1.0 Executive Summary

The purpose of this report is to review and assess the conceptual layout and mode of construction for the on-airport segment of the proposed Automated People Mover (APM) at Fort Lauderdale-Hollywood International Airport. The report focuses on the following four areas of interest:

4.0 Review of Automated People Mover Conceptual Support Structure at Rental Car Facility (RAC)

FIGURE 13

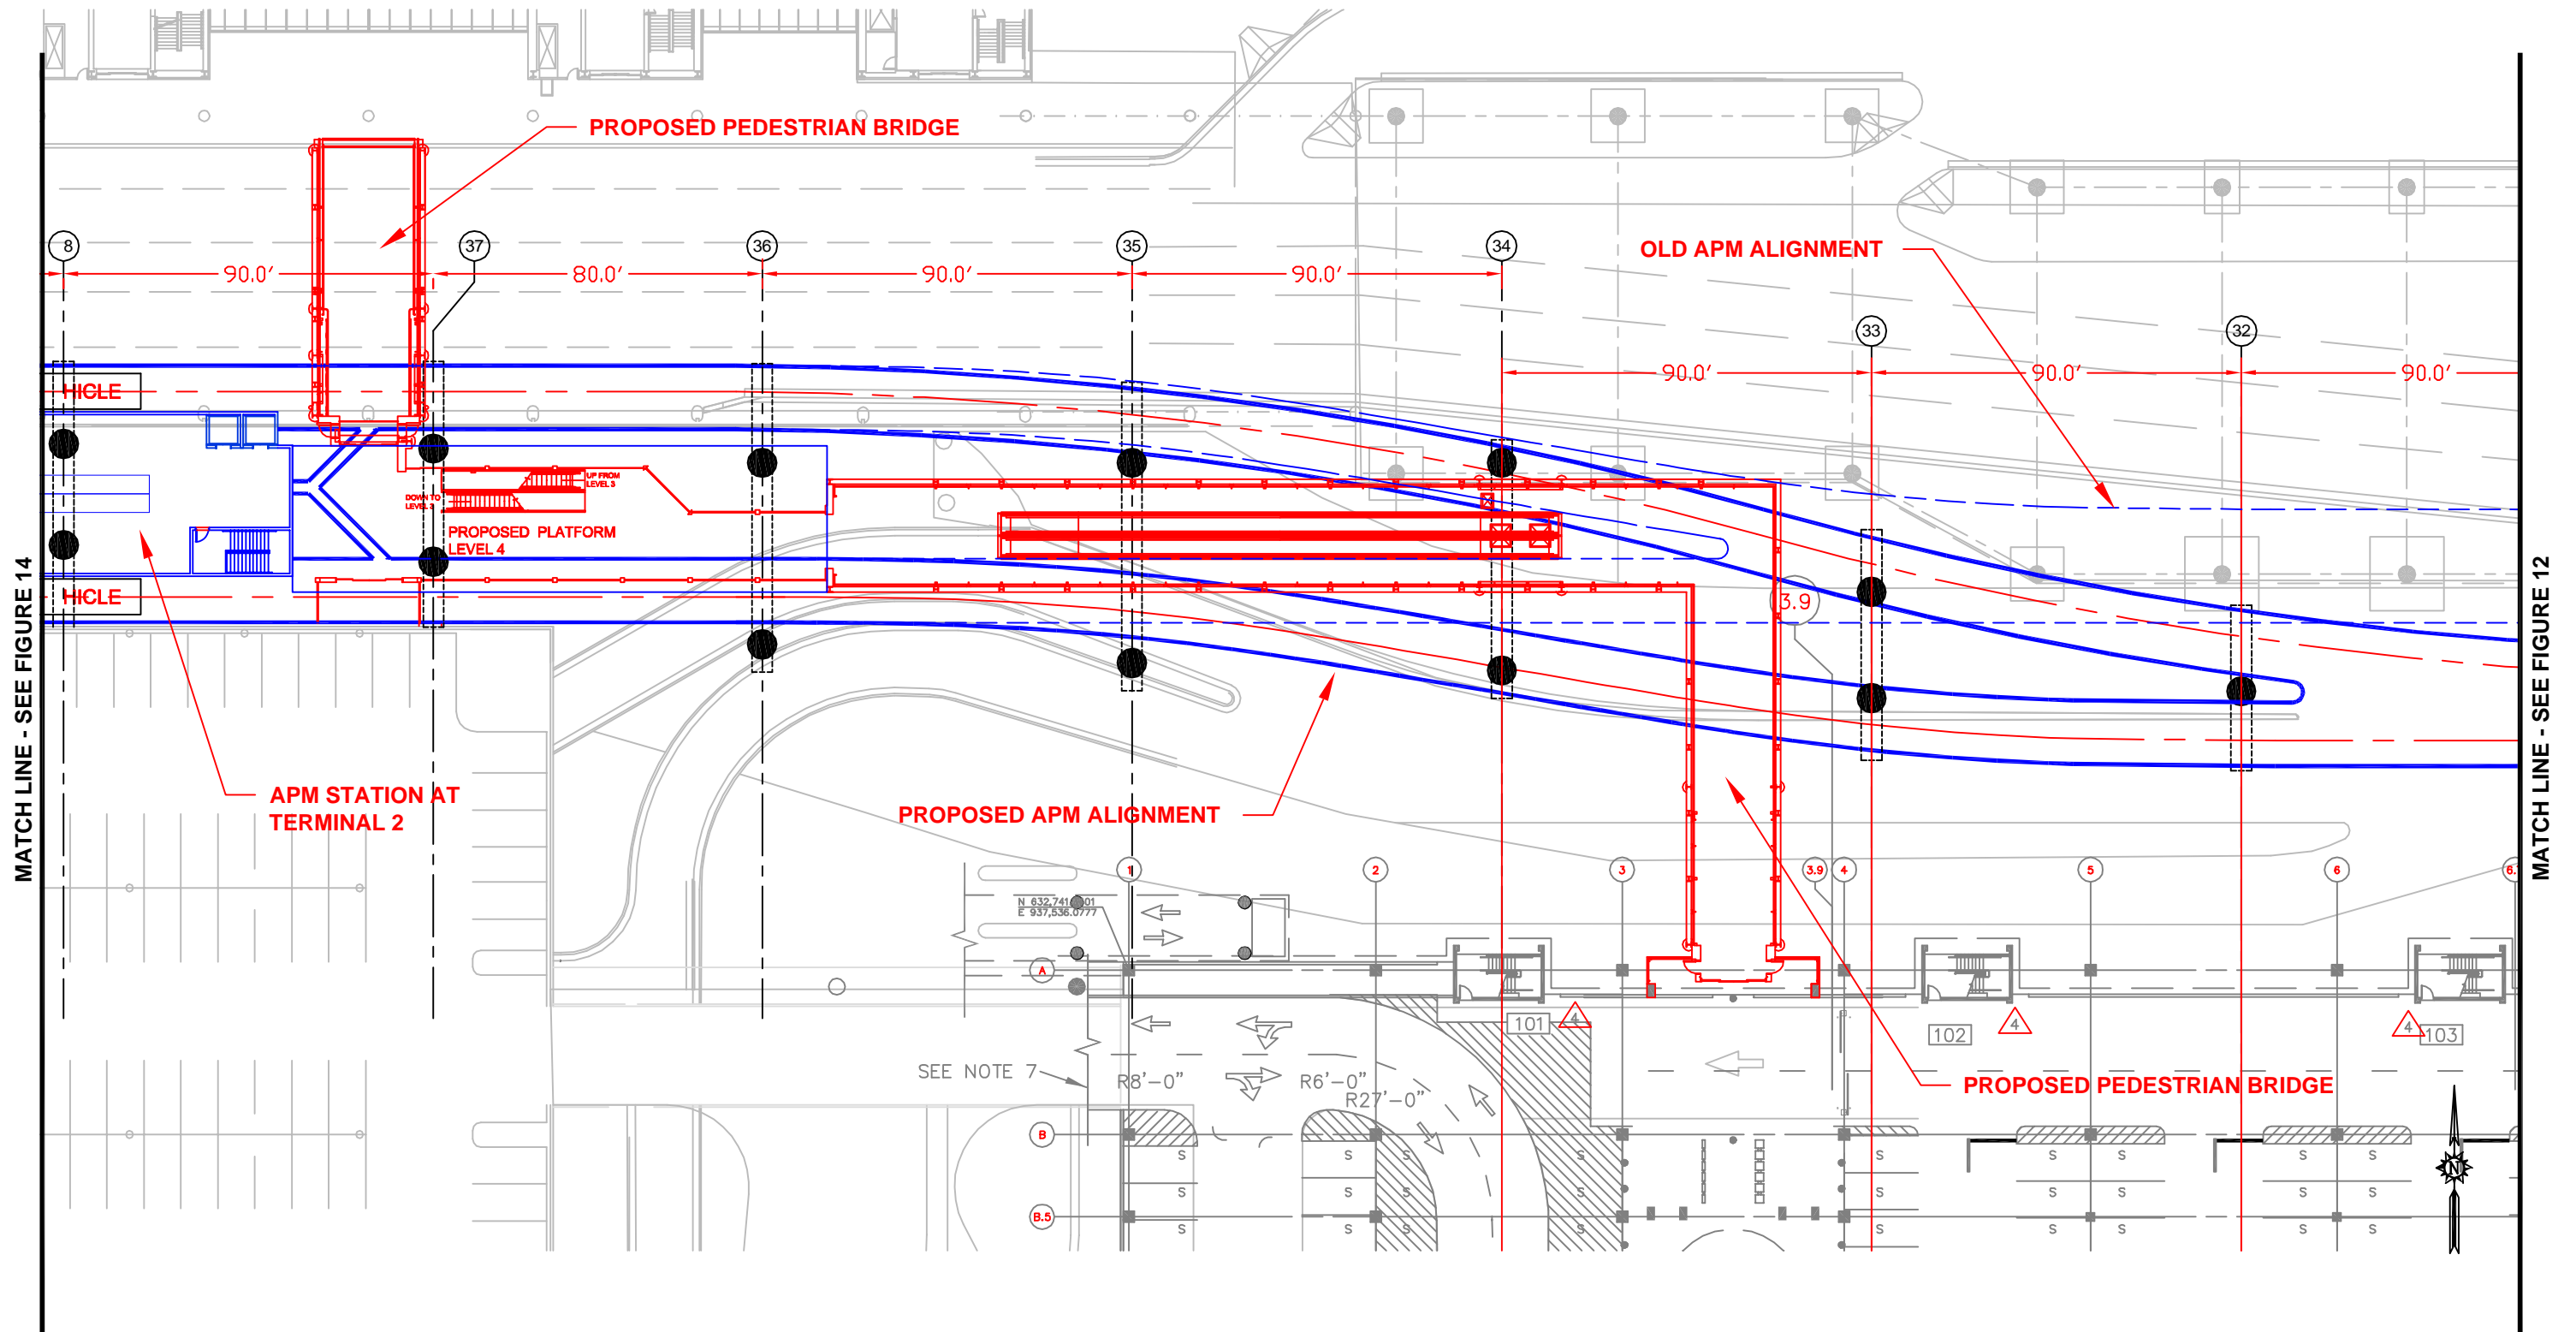
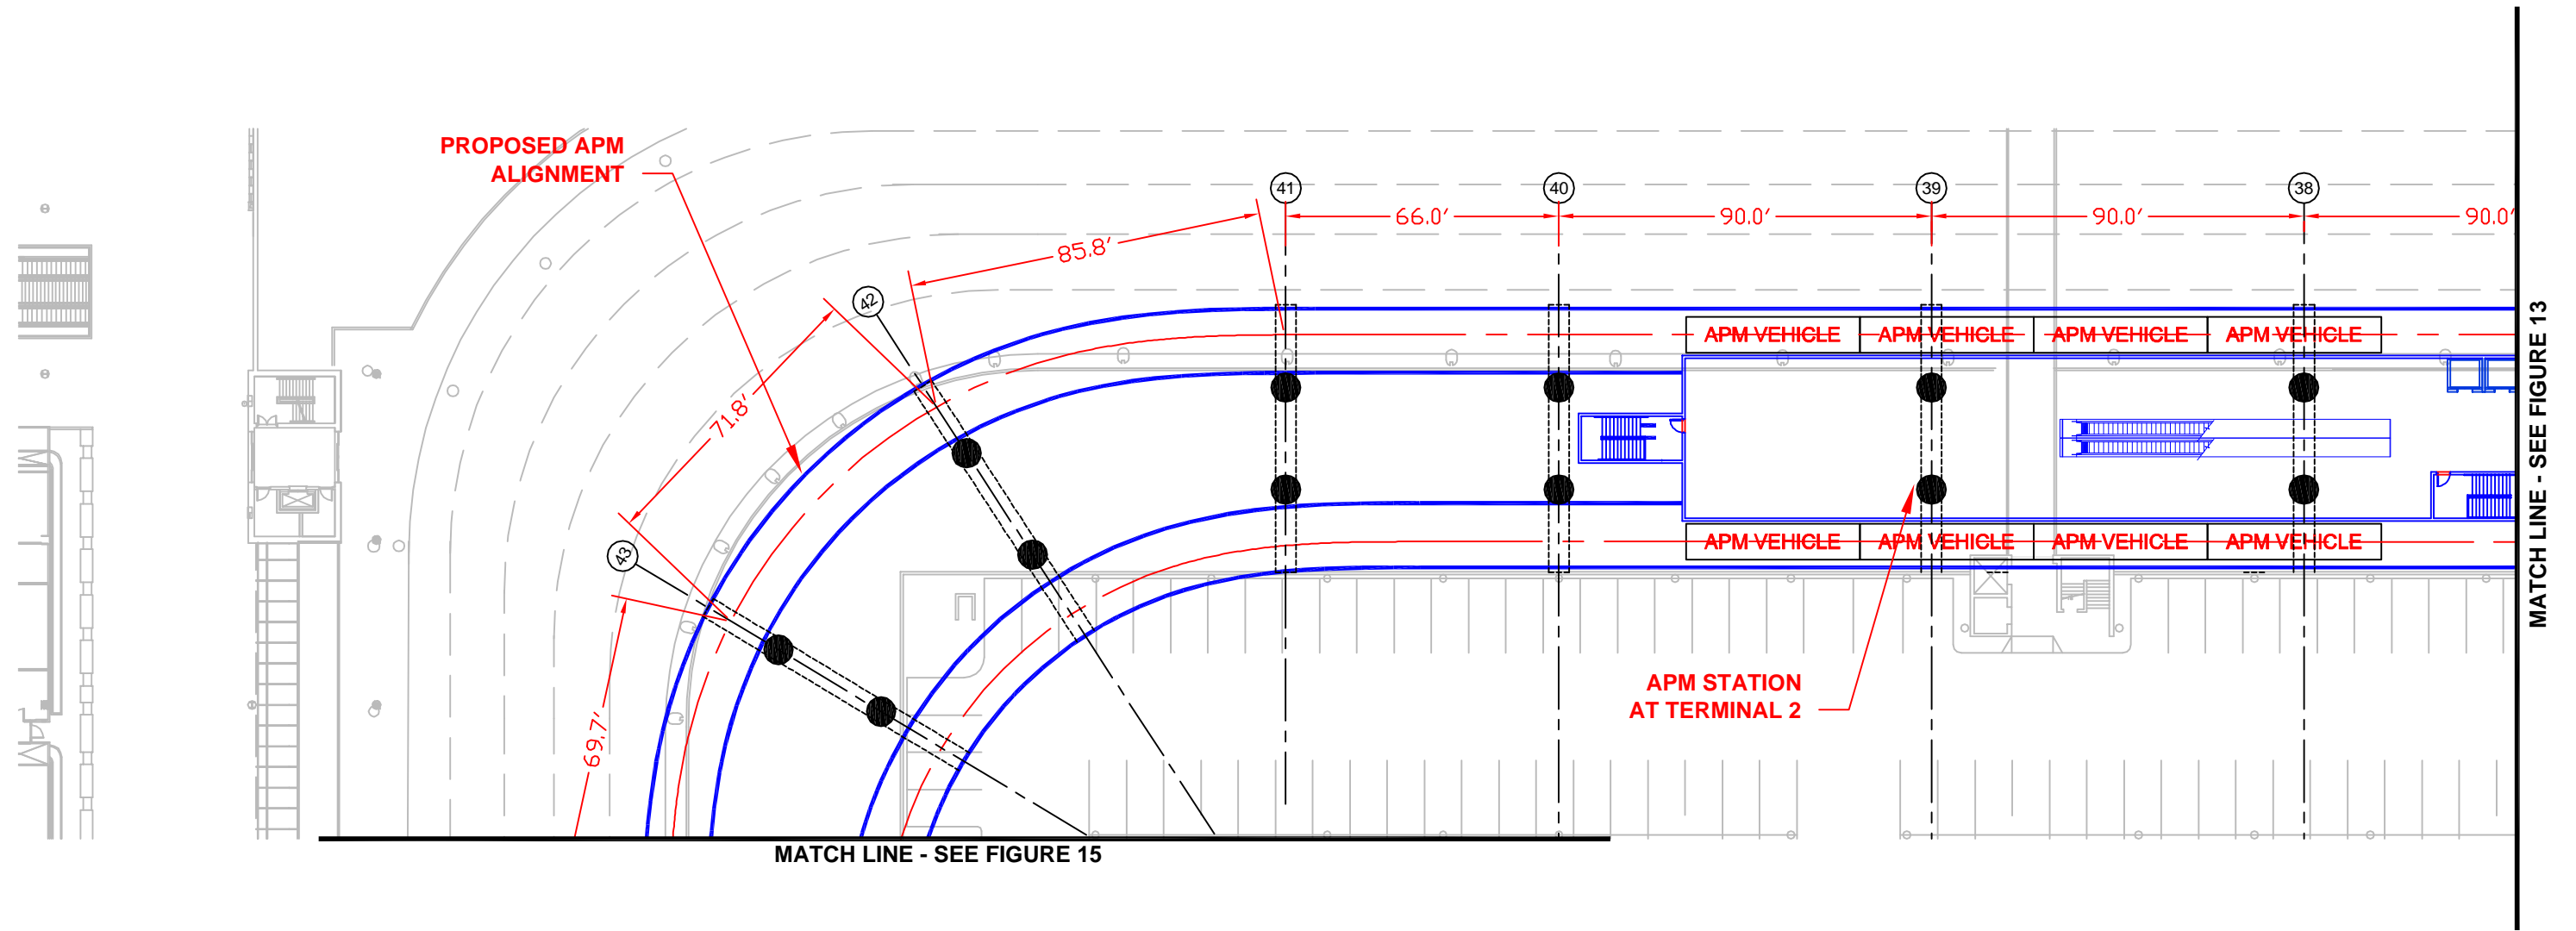
The layout and placement of support structures for the future APM guideway in the area of Terminal 2 necessitates that special attention be given to the interface between these future supports and construction of the pedestrian bridges (See Figure 13). For additional information concerning this area refer to the Progress Report and Project Update prepared by 2020 Vision (March 2002 to June 2002) Figures A-200 to A-202. In order to minimize the future impact of the APM construction on both the operations of the Airport as well as to the structures of the pedestrian bridges it is recommended that some of the construction for the future APM be incorporated into the Pedestrian Bridge Project. See Figures 13 and 14 for bent layout location in the vicinity of the Terminal 2.

It is recommended that the partial construction of bents 34 through 38 be incorporated into the Pedestrian Bridge Project (See Figure 16). This will assure that operational impacts to the Airport, which will have to reoccur during the Pedestrian Bridge Project, will not have to take place in the future when the APM is constructed. Another advantage is that the support structure for the APM can also be used to support the pedestrian bridges. Future construction of the APM will be made easier by extending the APM columns to just above the pedestrian bridges and providing mechanical couplers with threaded rebar in order to extend the APM columns in the future. Whether future APM bents are partly incorporated into the construction of the pedestrian bridges or they are built at a later date, it is important to observe the relationship between these bents and the existing and proposed structures.

FIGURE 15
 PROPOSED BENT LAYOUT FROM WEST OF RAC
 TO JUST SOUTH OF TERMINAL 3
 (BENT 44 THROUGH 50)

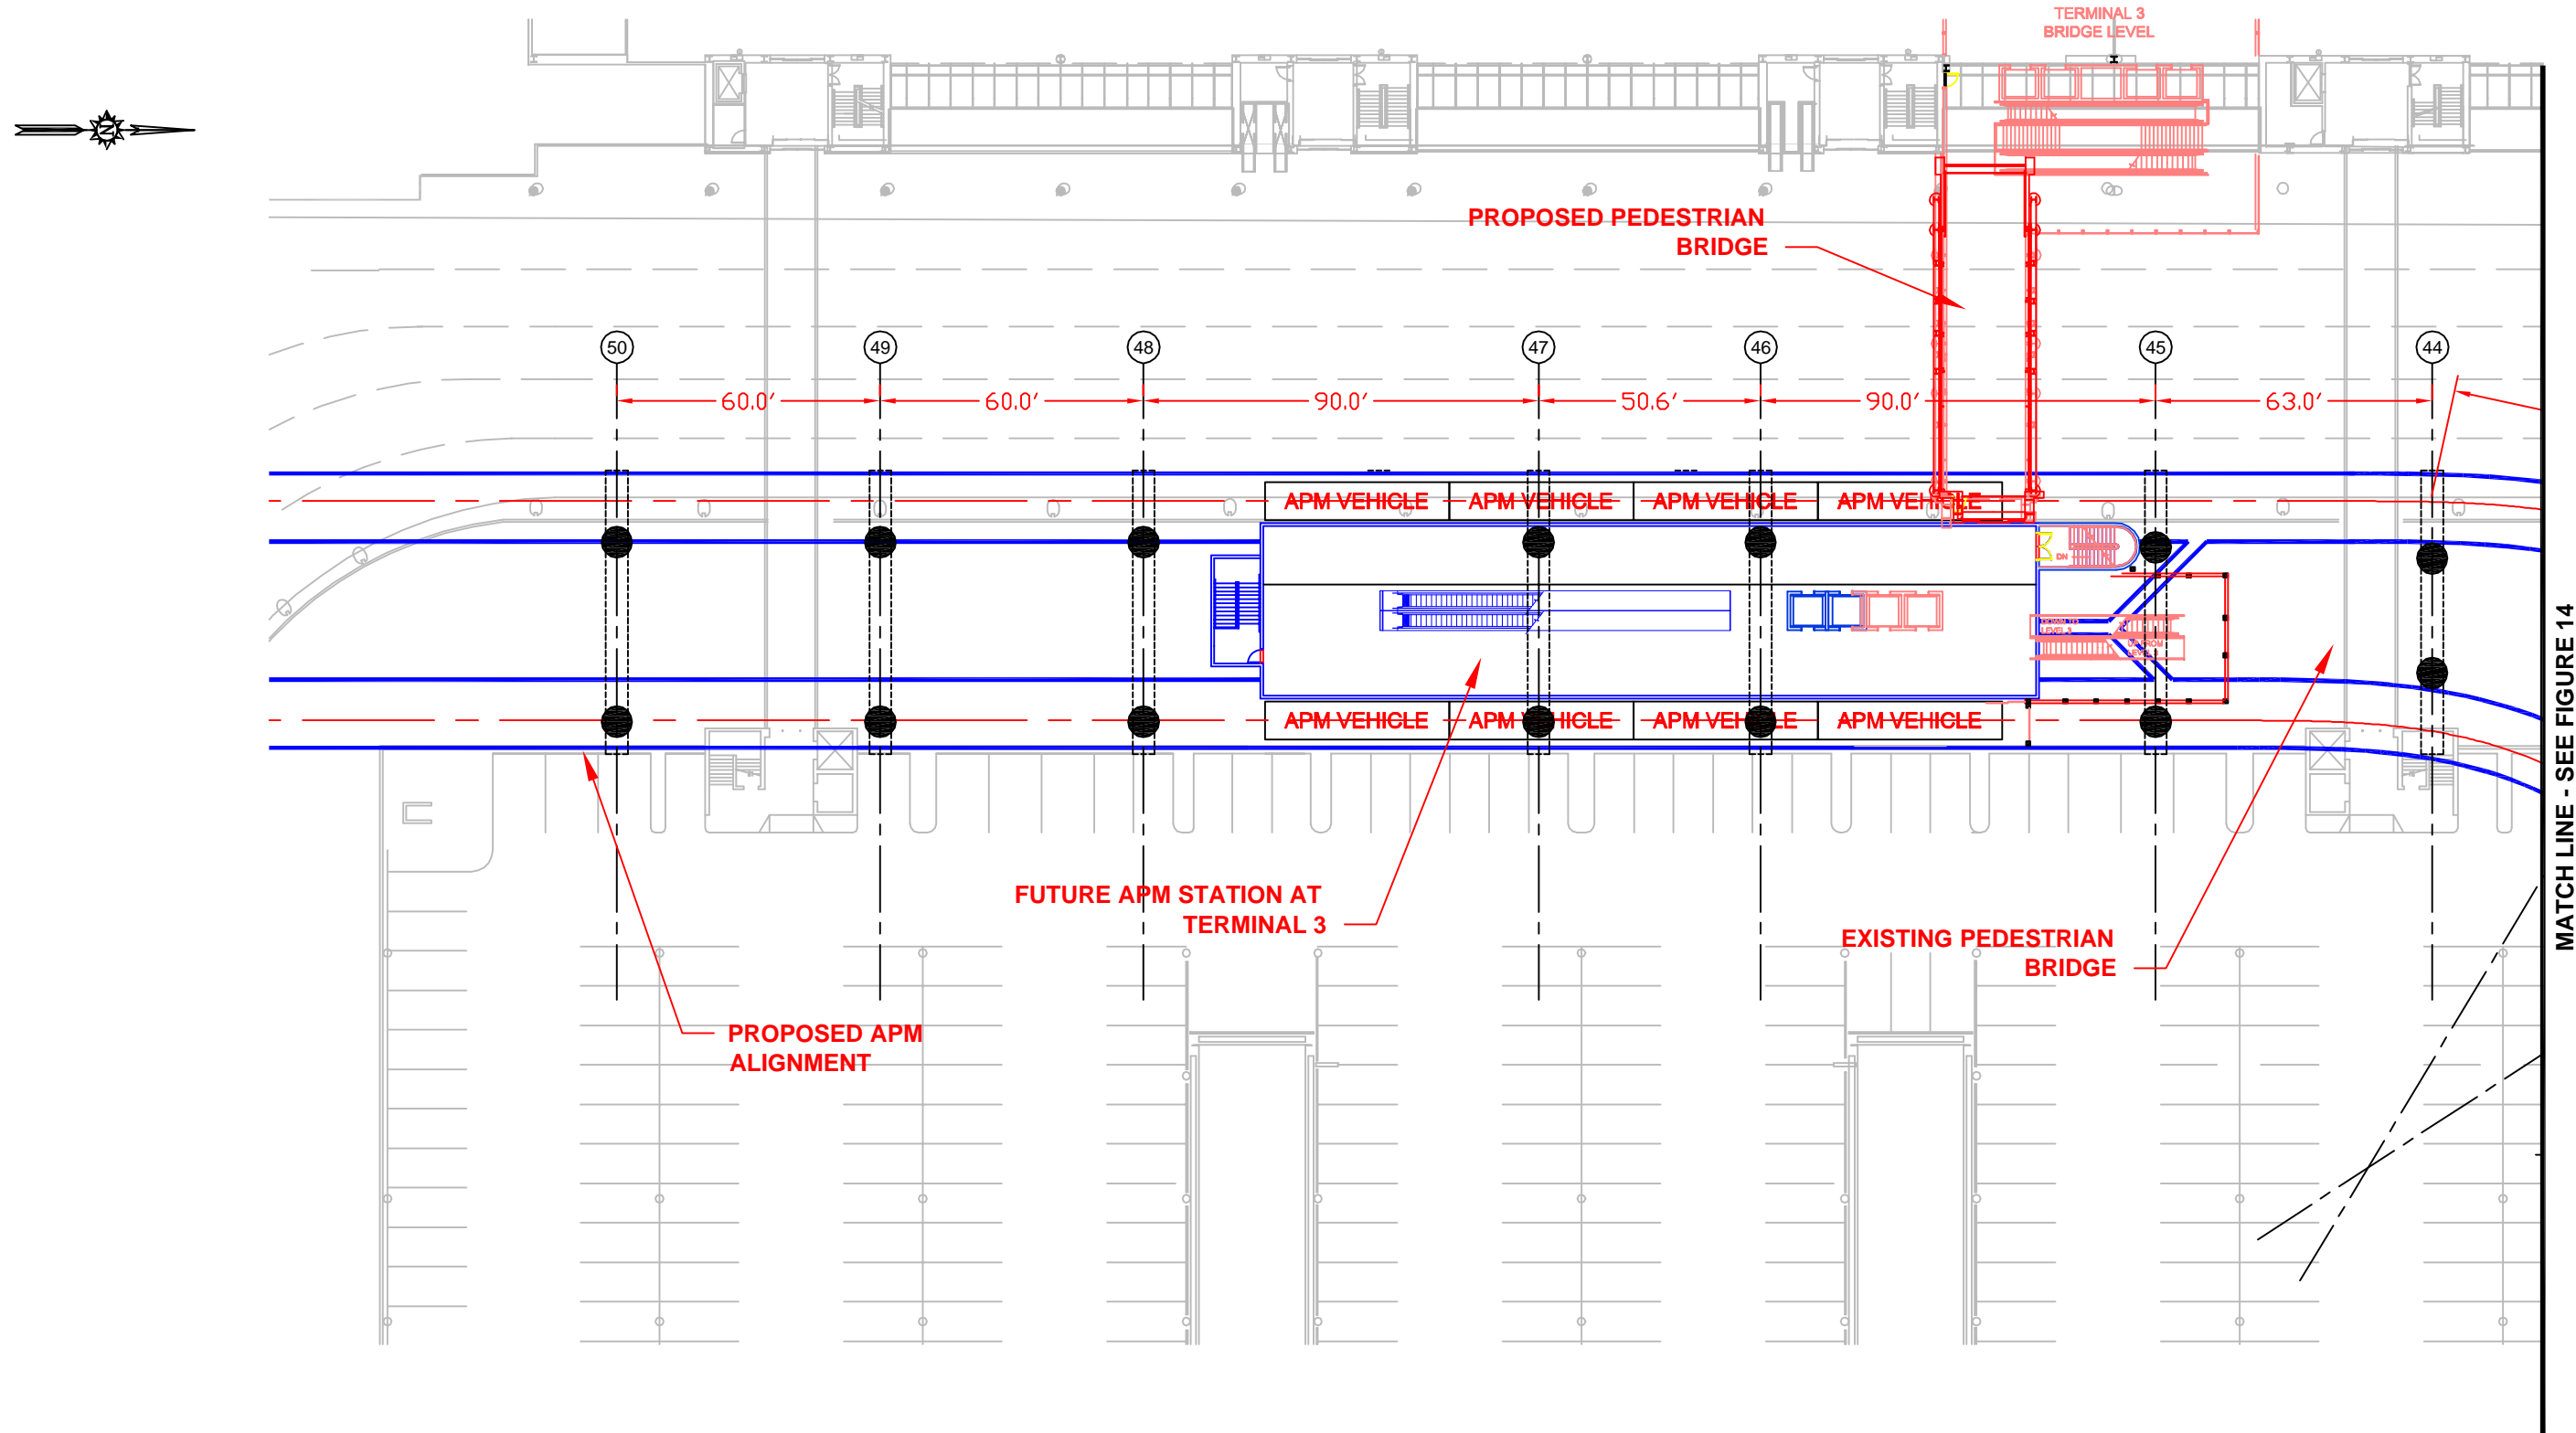
It is recommended that the partial construction of bents 45 and 46 be incorporated into the Pedestrian Bridge Project (See Figure 15) for the same reasons discussed in Section 5.0 above.
